Agenda Item #: 1

SUB-002790-2023

Hargrove Estates Subdivision, Resubdivision of Lot 1

APPLICATION NUMBER 1 DATE January 18, 2024

SITE PLAN

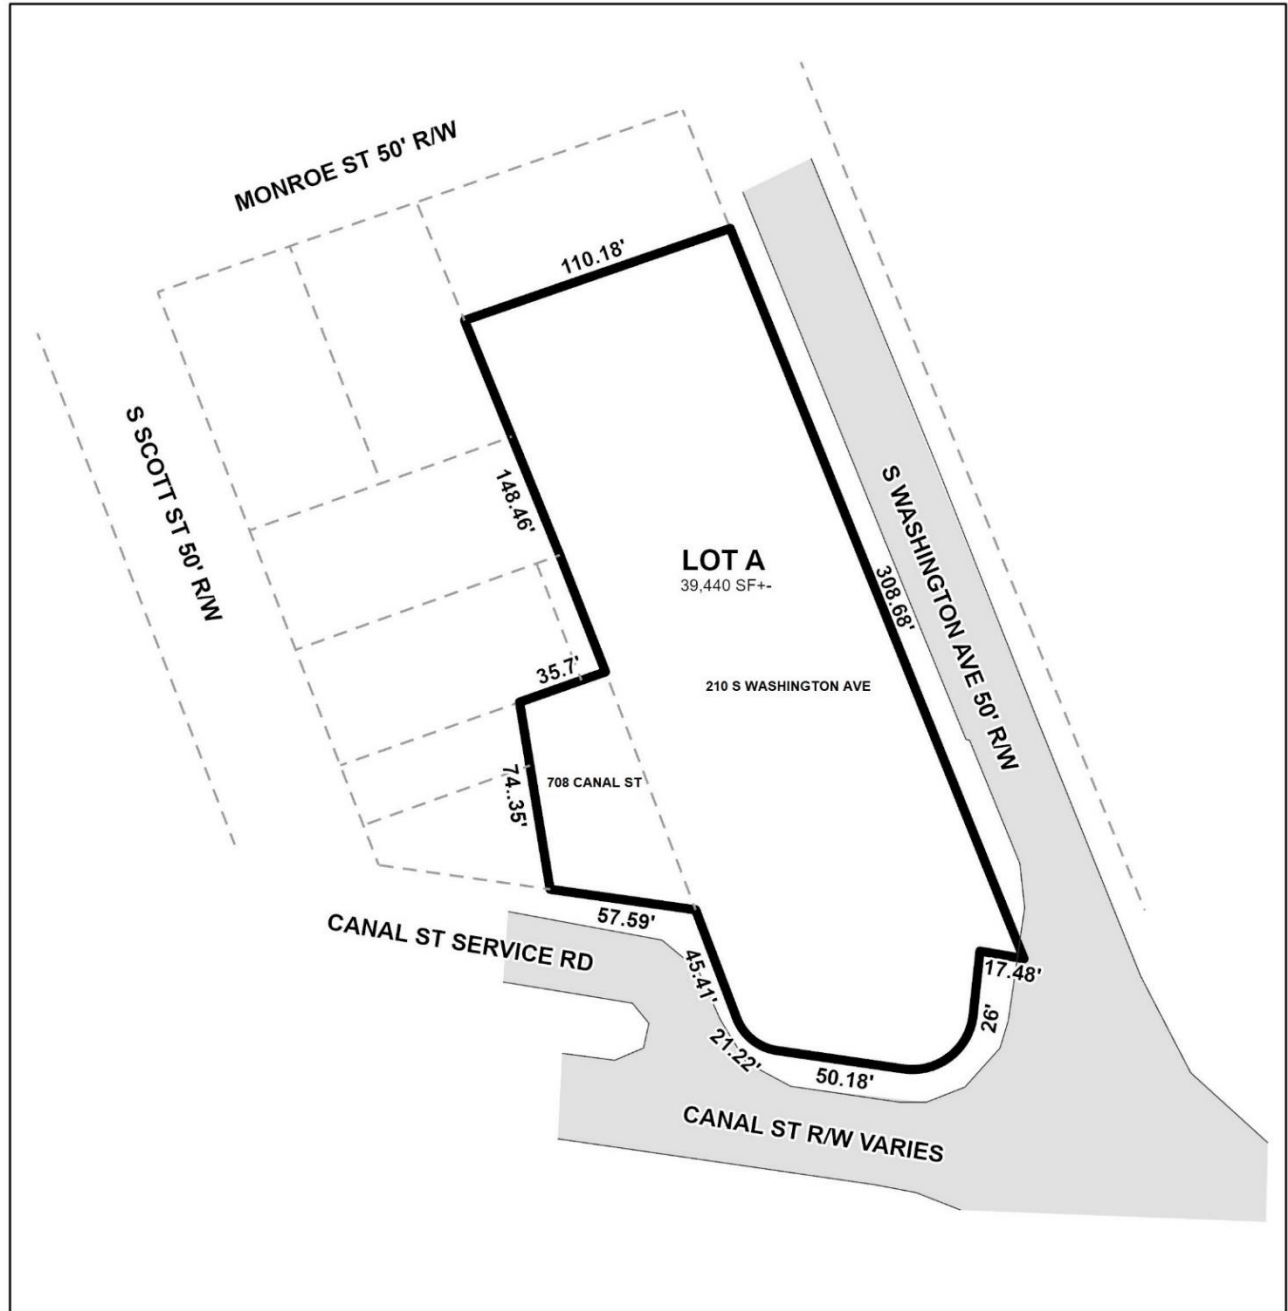
- B. Revise the "(REVISED)" in the Title Block to match the size, type, font of the rest of the Subdivision Name.
- C. Provide a written description for the proposed subdivision boundary.

- D. Dedicate the southeast corner of LOT A to City of Mobile public ROW. Extend line L2 and connect it to the eastern property line with a 15' or 20' radius. List the area of dedication in SF and AC.

- E. Show and label the MFFE (Minimum Finished Floor Elevation) on each lot that contains an A, AE, or X (shaded) flood zone designation. BFE = 12.
- F. Revise NOTE 13 to read – "As shown on the 1984 aerial photo (FLIGHT 30 - #72) LOT A will receive historical credit of existing (1984) impervious area towards stormwater detention requirement per Mobile City Code, Chapter 17, Storm Water Management and Flood Control) as follows: LOT A – 32,000 SF."

- G. Add a note that sidewalk is required to be constructed, and/or repaired, along the frontage of each lot, or parcel, at time of new development or construction, unless a sidewalk waiver is approved.

- H. Revise NOTE 12 to read – "All existing and proposed detention facilities, common areas, and wetlands shall be the responsibility of the Property Owner(s), and not the responsibility of the City of Mobile."

The site has frontage on South Washington Avenue, a minor street with curb and gutter requiring a 50-foot right-of-way, and Canal Street, a minor arterial street requiring a 120-foot right-of-way. The preliminary plat depicts a 50-foot right-of-way along South Washington Avenue, making no dedication necessary. The preliminary plat states that the right-of-way along Canal Street varies, however it should be noted that the Hargrove Estates Subdivision did not require any dedication along Canal Street in 2005, therefore the plat should be revised to depict there is a minimum of 60-feet to the centerline of Canal Street, if approved.

The subject site is zoned T-4, which requires newly platted lots to have street frontage between 18-feet and 120-feet. The proposed lot has over 150-feet of frontage along Canal Street and over 300-feet of frontage along South Washington Avenue. As such, if the Planning Commission is inclined to approve the application, a waiver of Section 6.C.2.(b)(1) of the Subdivision Regulations will be required.

Properties located within a T-4 sub-district are allowed a 12-foot maximum setback along both street frontages. If approved, the maximum setback line should be depicted on the Final Plat, if approved.

The preliminary plat provides the proposed lot size in square feet and acres. If approved, this information should be retained on the Final Plat or a table should be furnished on the Final Plat providing the same information.

1. Retention of the existing right-of-way along South Washington Avenue;
2. Depict that there is currently 60-feet from the subject site to the centerline of Canal Street;

3. Depiction of the 12-foot maximum setback;
4. Retention of the lot sizes in both square feet and acres, or the furnishing of a table on the Final Plat providing the same information;
